## Gate two query process

<b>Strategic solution(s)</b>	Severn Thames Transfer
<b>Query number</b>	STT005
<b>Date sent to company</b>	09/12/2022
<b>Response due by</b>	13/12/2022

Figure 7-1: Project-level plan

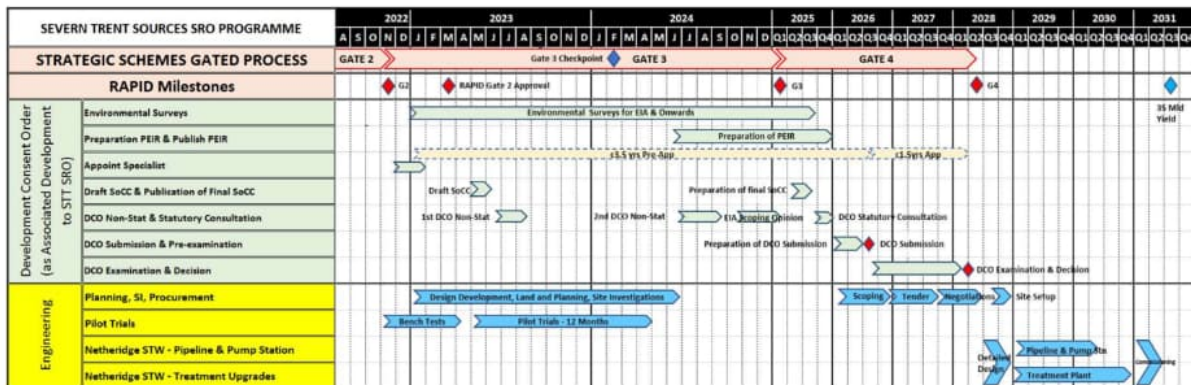
Could you confirm/clarify the role of Mythe and Shrewsbury in your proposed solution submitted at Gate 2, including any timelines. The summary programme for earliest delivery Fig 7-1, doesn’t seem to include the dates for where Netheridge, (or Mythe or Shrewsbury) come into play to support the STT SRO – Minworth and NWT SRO’s are listed. Netheridge is cited as critical to STT (Fig 7-2).

With reference to the omission of the Netheridge source from STT figure 7.1, below is an extract from the corresponding Severn Trent Sources Gate 2 report which provides the programme activities for Netheridge. This shows that Netheridge source, as an integral element for sweetening flows to the interconnector, can be delivered within the overall STT programme, and ahead of the earliest STT interconnector commissioning in 2033.
